Environmental Review Team Report

Whitehall Subdivision

Stonington, Connecticut

March 1985

Bedrock Geology

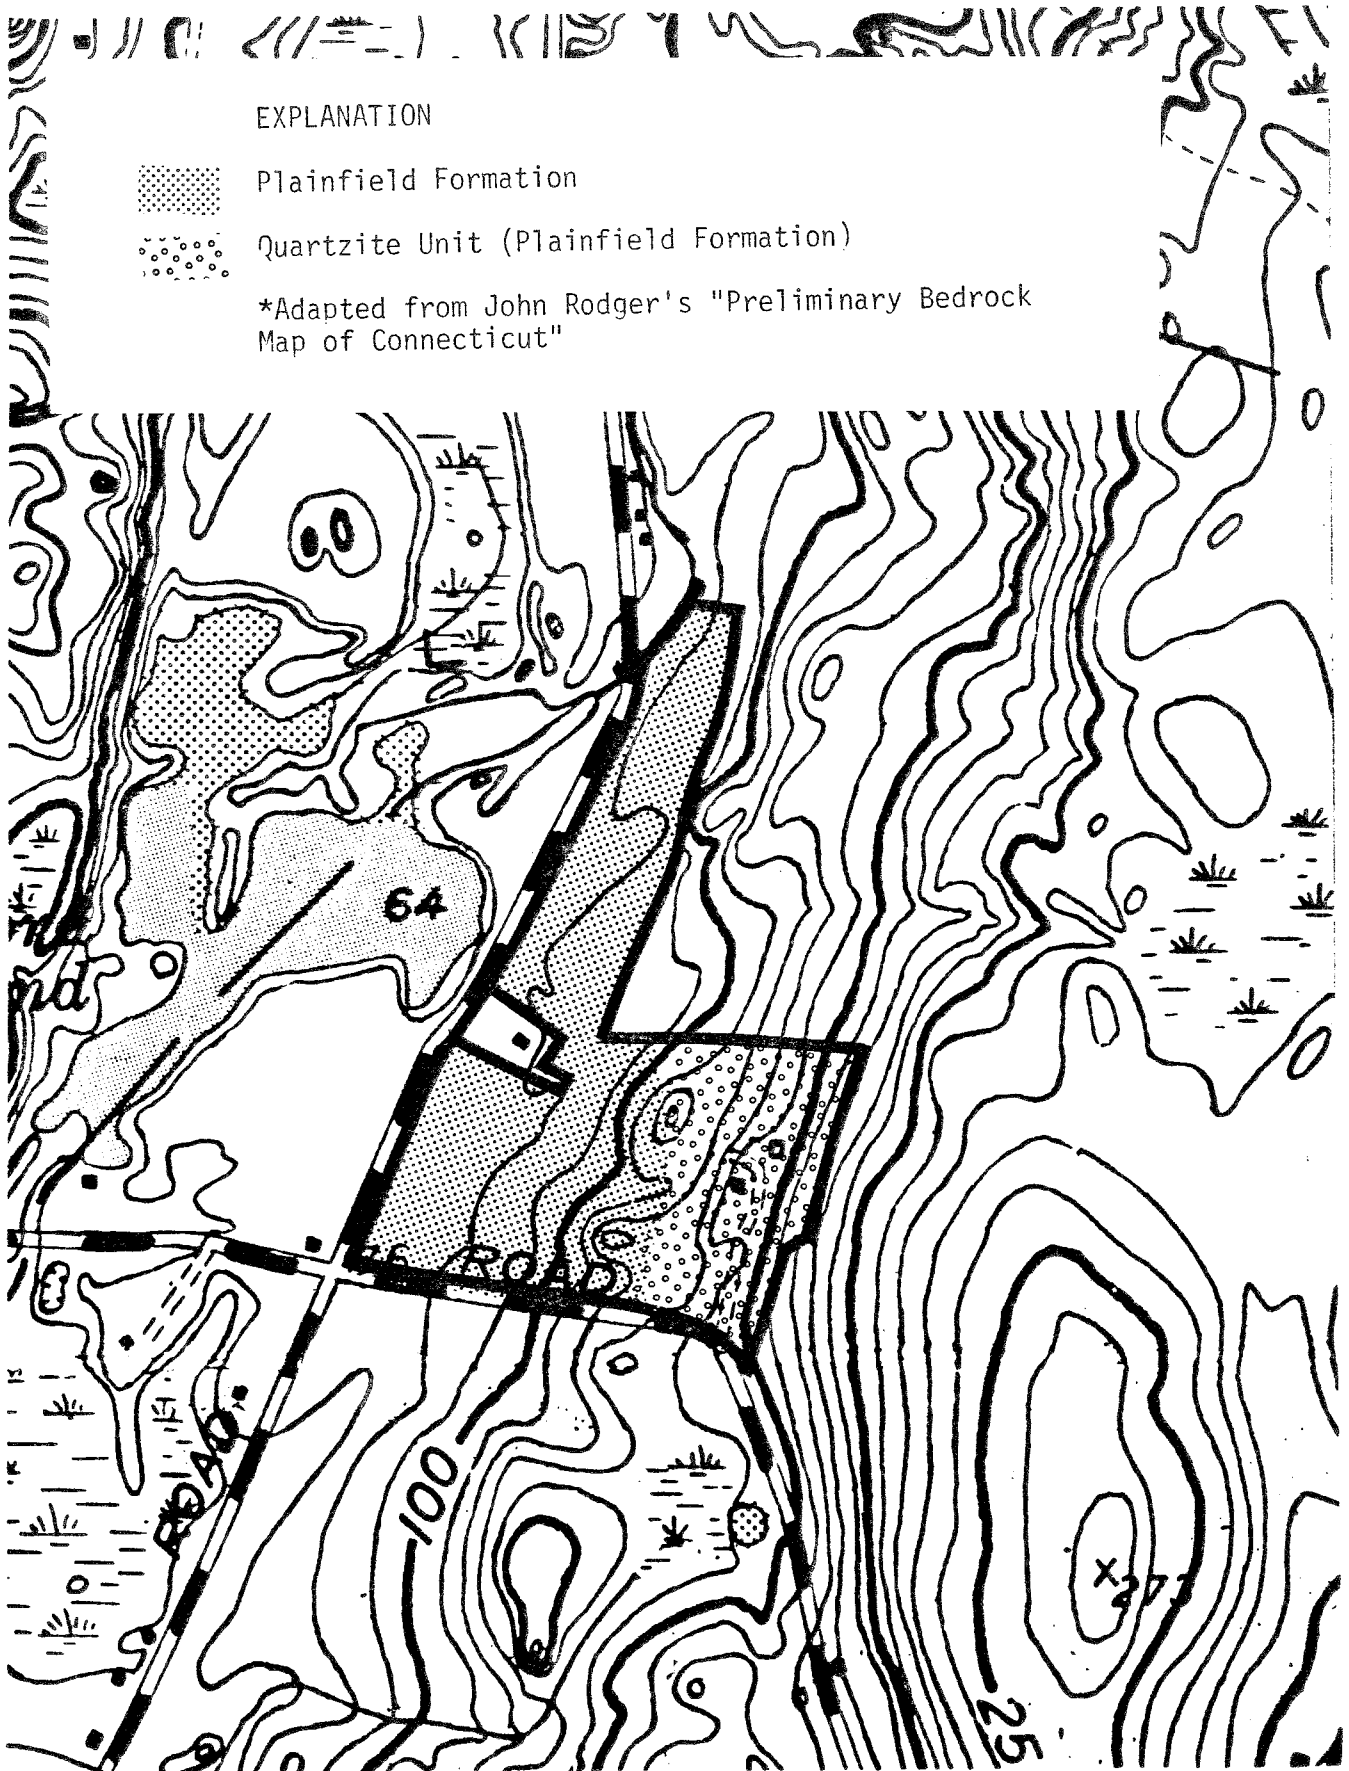
having a rounder or blockier shape. A "schist" is a layered rock that parts relatively easily along surfaces of mineral alignment. Finally, a "quartzite" is a light colored granular (equal grain size) rock composed essentially of the mineral quartz. All of these rocks are crystalline metamorphic rocks (rocks geologically altered by great heat or temperature). Because of the snow cover on the site during the field review, rock outcrops were not easily visible. According to the project engineer, areas where bedrock is at or near ground surface is primarily in the area designated as Open Space.

Drainage Areas

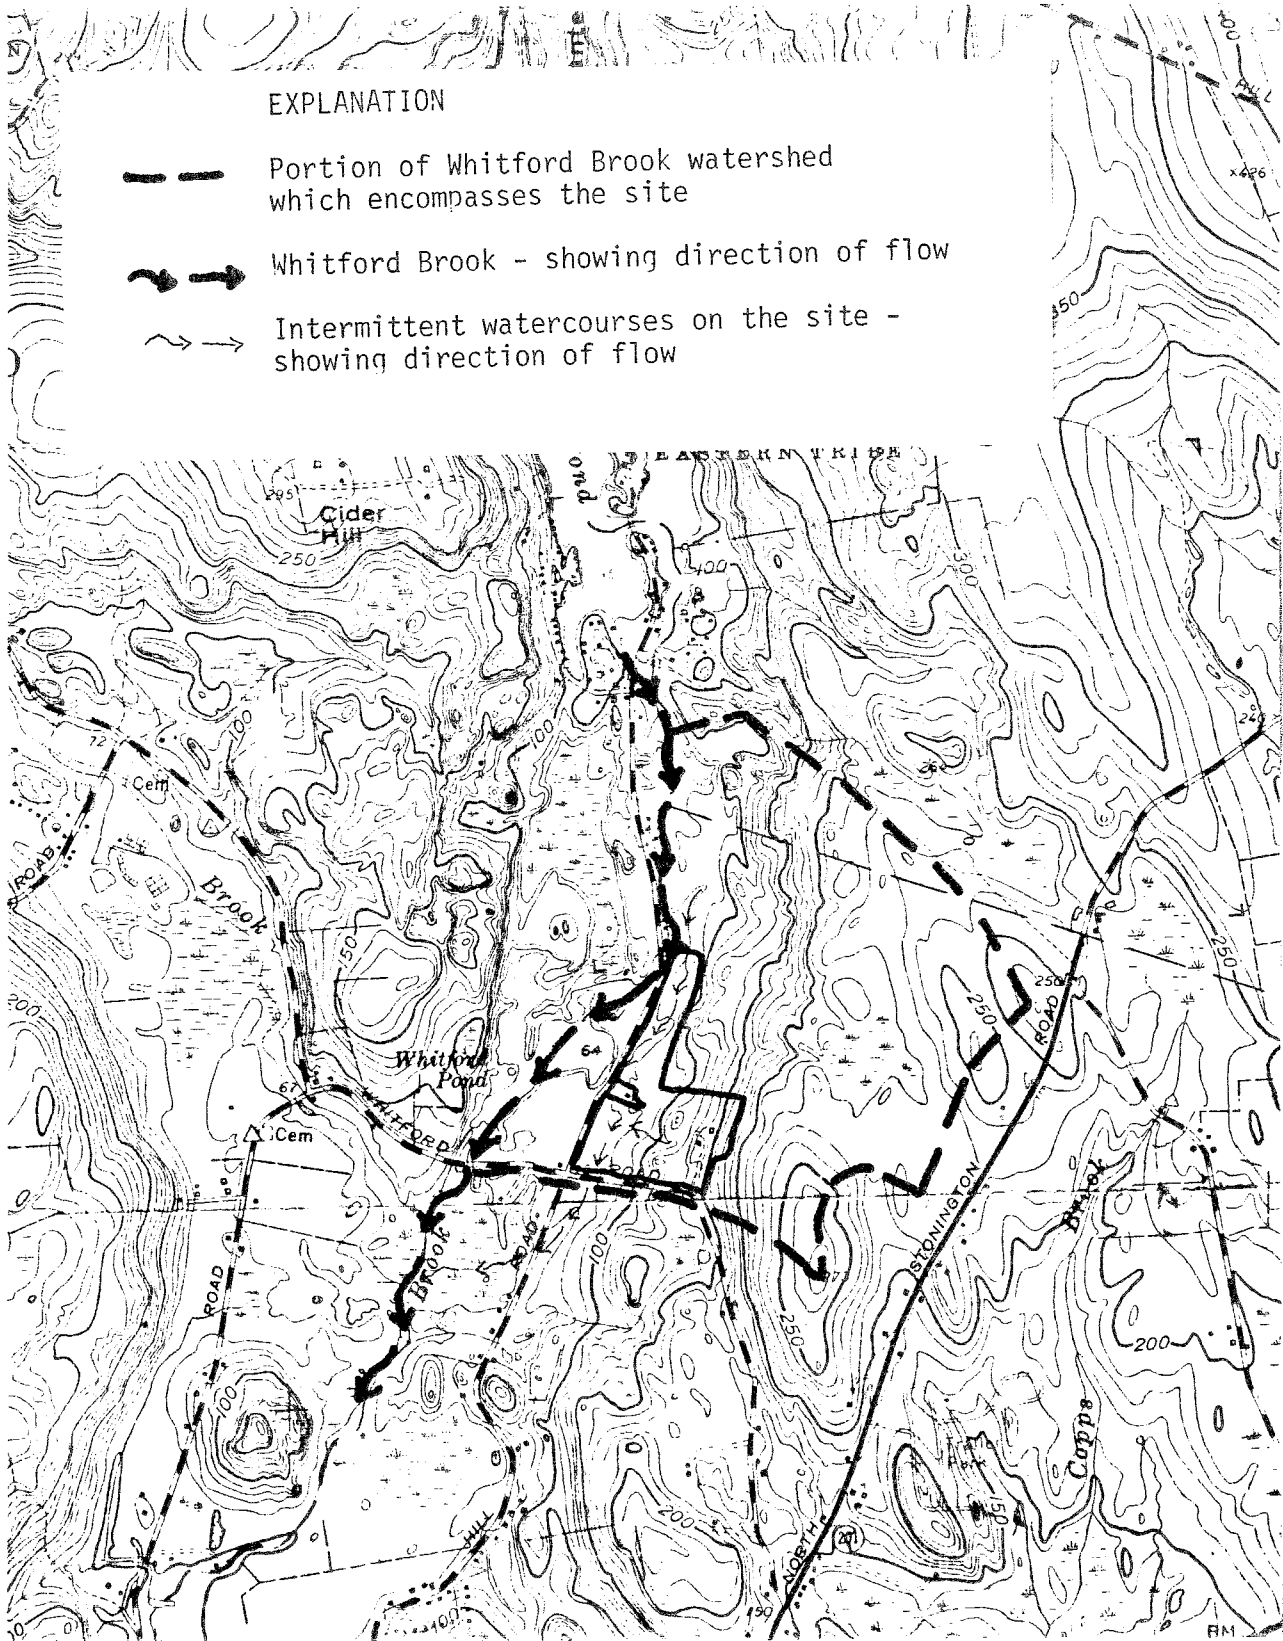
It is strongly recommended that the project engineer closely examine the 18" and 15" culverts passing under Lantern Hill Road in front of the Avery residence and lot 7, respectively, to ensure that they can handle post development flows.

As mentioned earlier, slopes in the eastern portion are moderate. For this reason, every effort should be made to prevent potential erosion and siltation problems, particularly near wells, streamcourses, as well as Whitford Pond and Brook. Therefore, it is recommended that a comprehensive erosion and sediment control plan be developed covering each stage of the proposed subdivision since increased runoff from developed areas may cause streambank erosion and gullyng ultimately causing siltation problems to downstream areas. All erosion and sediment control measures should be shown on the subdivision plan which receives final approval.
